25/00712/FUL: Installation of a battery energy storage system, associated infrastructure, landscaping and access, Braybrooke

25/00810/FUL: Installation of a Battery Energy Storage System (BESS), associated infrastructure, landscaping, and access

25/00818/FUL: Installation of a Battery Energy Storage System (BESS), associated infrastructure, landscaping, and access

Site area shown on a photograph from the Visual Impact Assessment

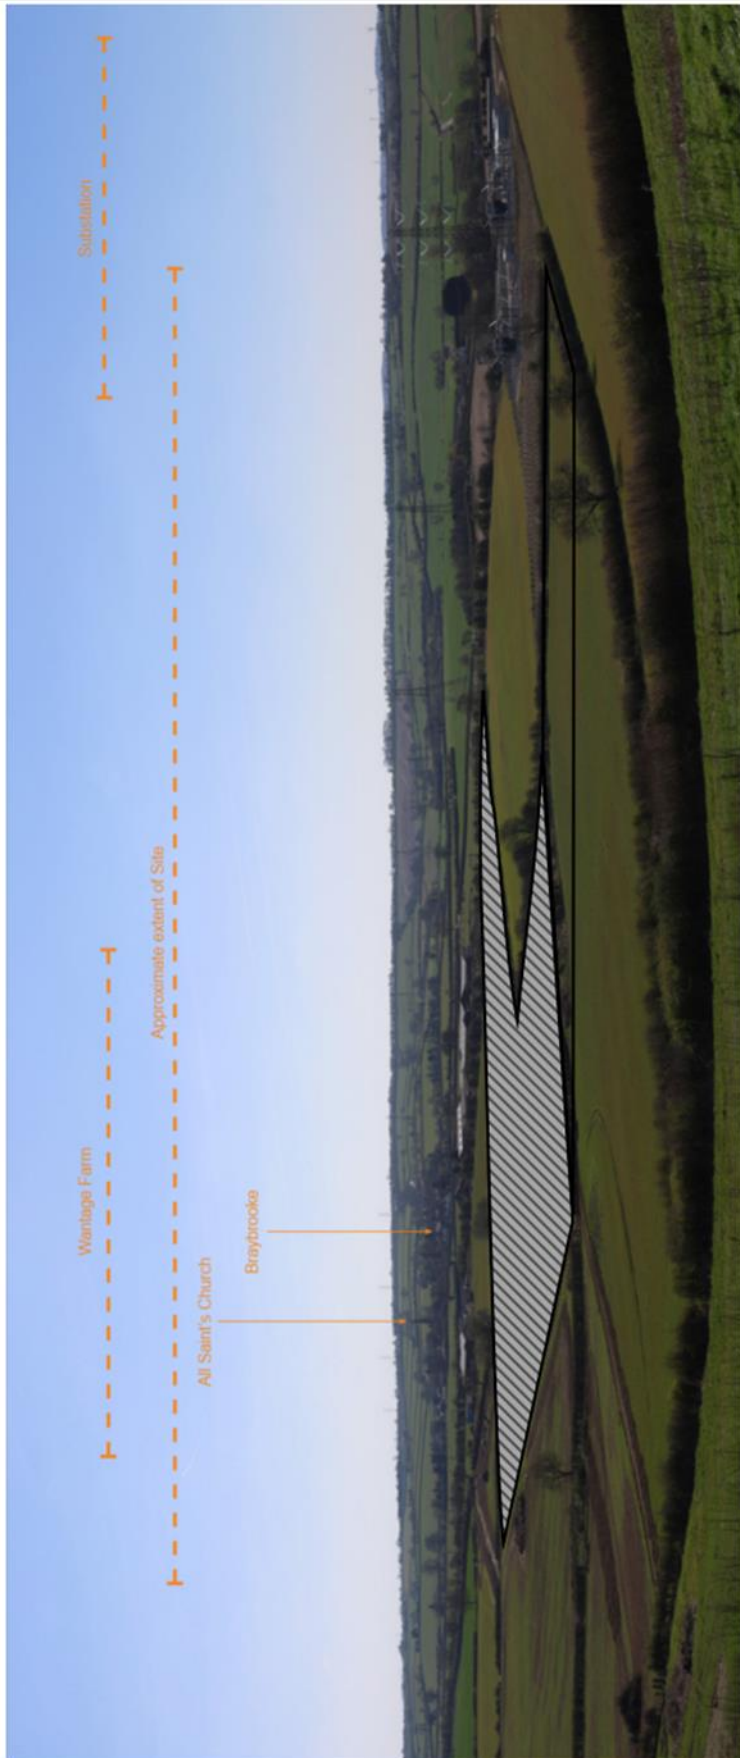
The applicant has failed to demonstrate that the development will not present a visual blight on views in the vale. Eight photographs of significant views are referenced, however there has been no attempt to image the development, so it is impossible to draw any conclusions regarding the visual impact. In particular the intention to erect a 4m high acoustic fence on the perimeter is considered an additional visual intrusion of inappropriate type in a rural landscape. A simple example of adding imagery to a view is appended to this response.
